Landscape Referral Response

Application Number:	DA2024/0685
Date:	05/07/2024
Proposed Development:	Alterations and additions to a dwelling house including a swimming pool and carport
Responsible Officer:	Lachlan Rose
Land to be developed (Address):	Lot A DP 106210 , 58 Alexander Street MANLY NSW 2095

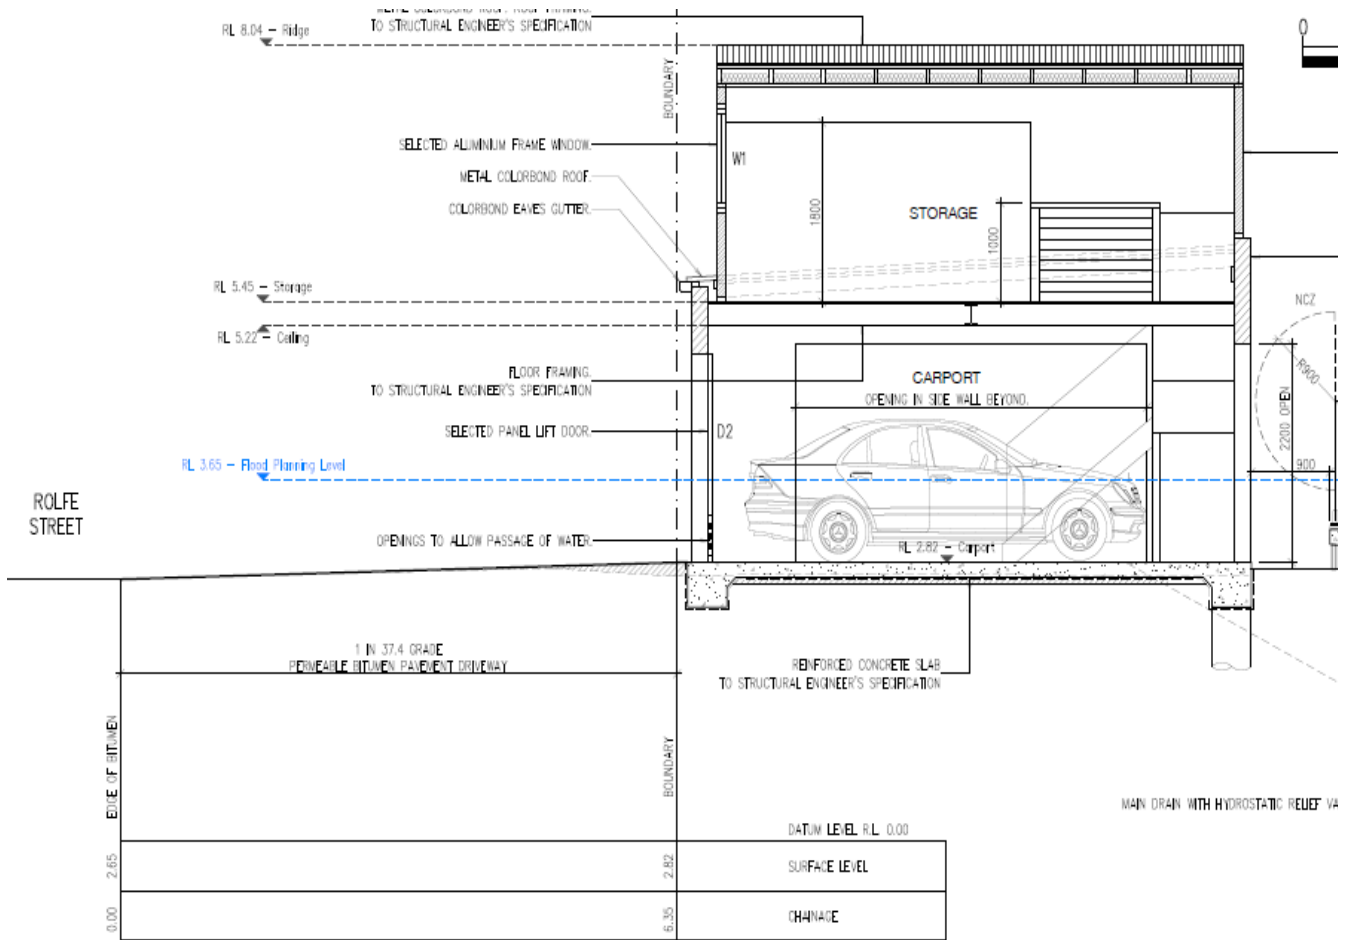
3.1 To ensure that the subject *Ficus rubiginosa* will not be impacted by the proposed driveway crossover, the area hatched in magenta below will be required to be constructed above existing grade.

3.2 Root mass observed at the eastern border of the proposed crossover will prevent piers being constructed in this location. A cantilevered or suspended section will be required in this section.
